SERVICE BULLETIN 670BA–24–040

SUBJECT: Electrical Power – Air Driven Generator – Replacement of Locking Cam Screw and Cam Nut Assembly

This page transmits:
Revision A of Service Bulletin 670BA–24–040, dated Nov 07 /2023.

**Locking Cam Screw and Cam Nut Assembly Replacement
Figure 1 (Sheet 1 of 2)**

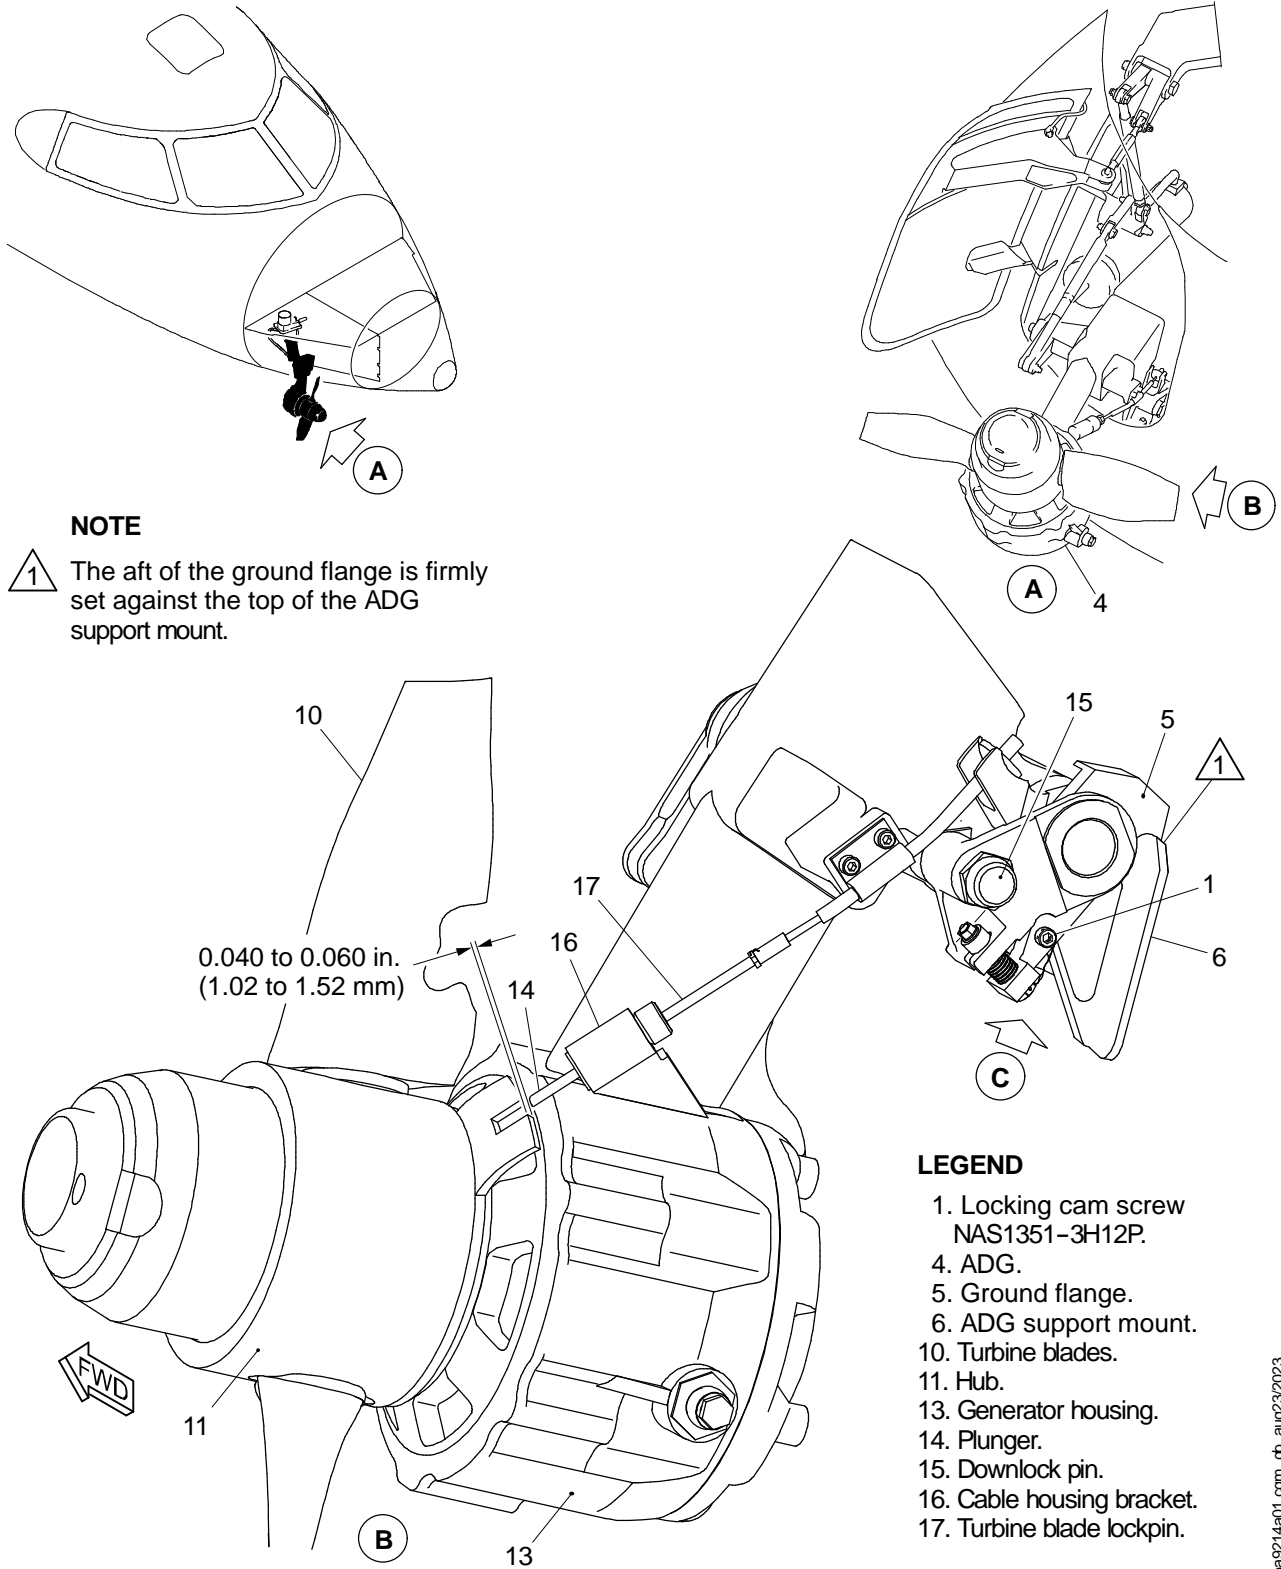
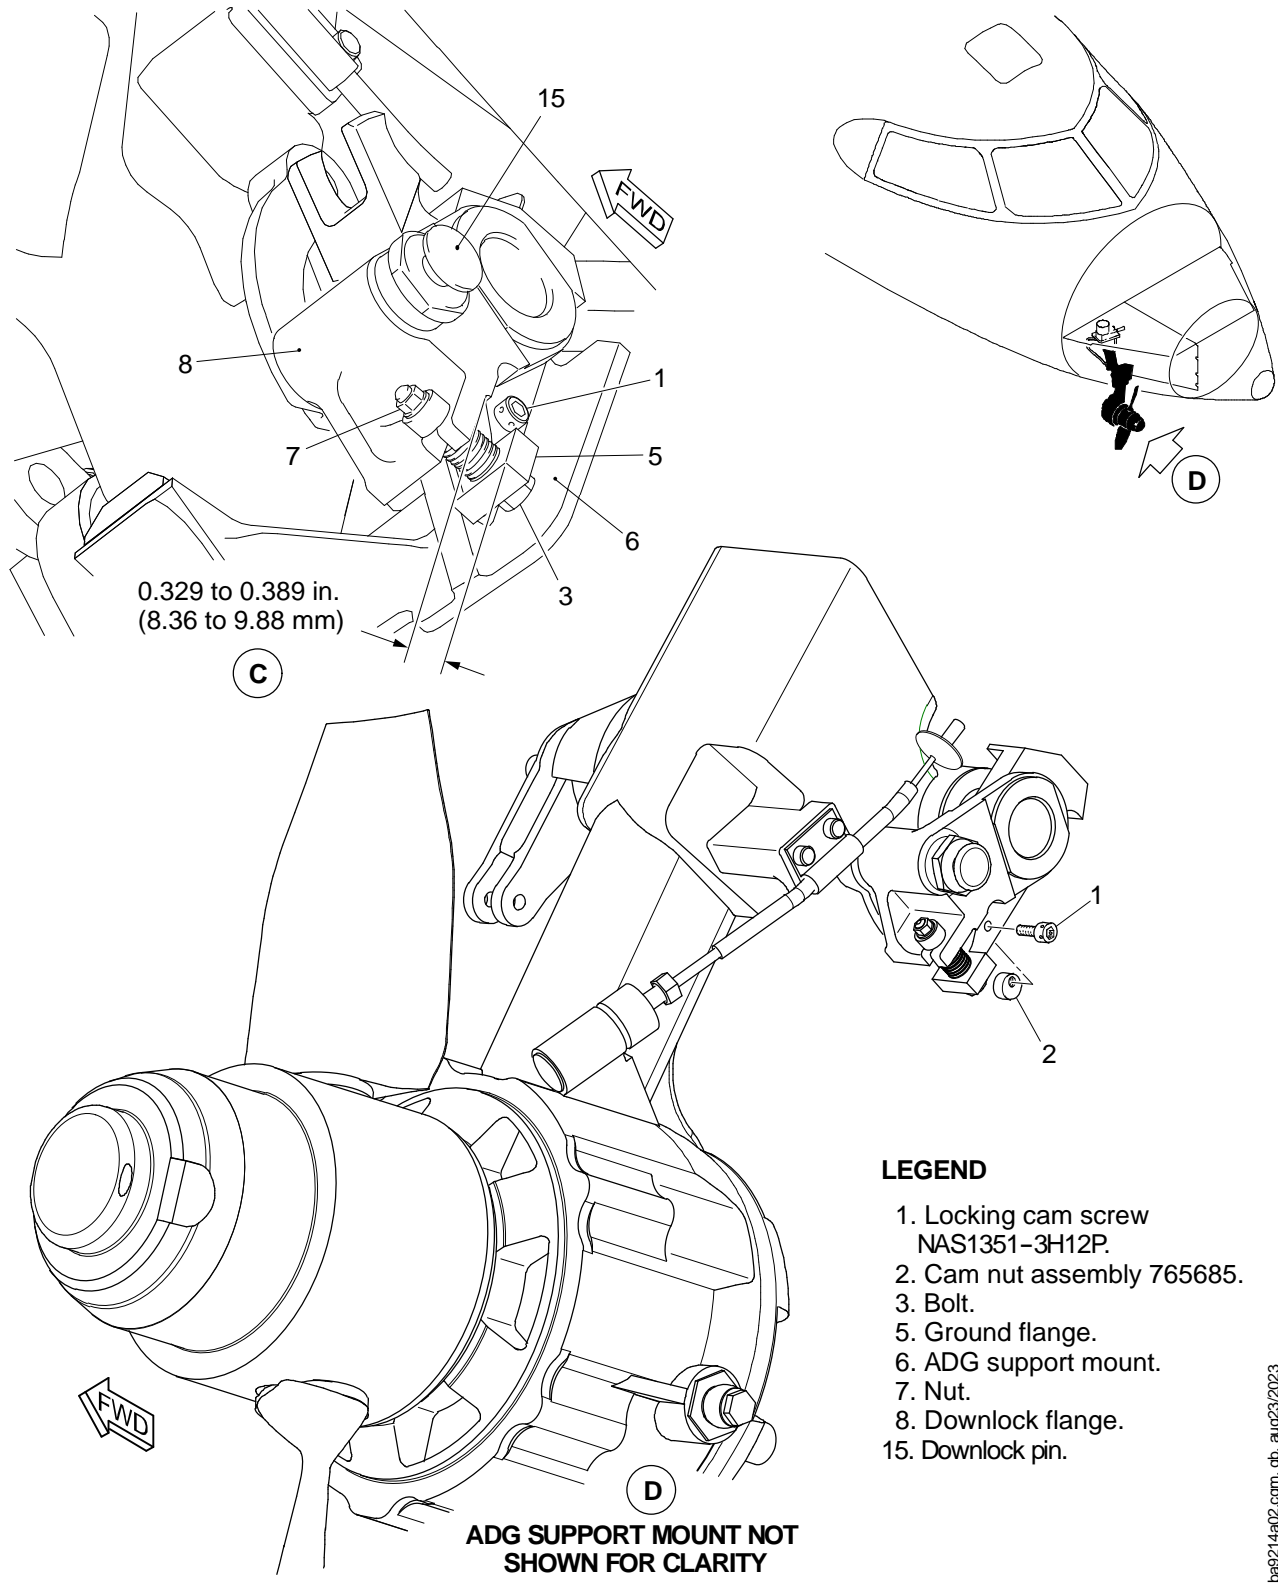
- (2) Remove and replace the locking cam screw (1) and the cam nut assembly (2) as follows:

- (a) Remove and discard the lockwire or safety cable from the locking cam screw (1) and the bolt (3) (refer to AMM 20–51–00–000–802 or AMM 20–51–00–000–807).
- (b) Remove and discard the locking cam screw (1) and the cam nut assembly (2) from the ground flange (5).
- (c) Install a new locking cam screw (1) with a new cam nut assembly (2) on the ground flange (5).

2 Lightly move the ADG (4) forward to firmly set the aft of the ground flange (5) against the top of ADG support mount (6) as shown on view B.

4 Torque the locking cam screw (1) to 51–56 lbf in. (5.8–6.3 N•m).

6 Check and, if necessary, adjust the nut (7) to get a clearance of 0.329 to 0.389 in. (8.36 to 9.88 mm) between the lower ends of the ground flange (5) and the downlock flange (8) as shown on view C.
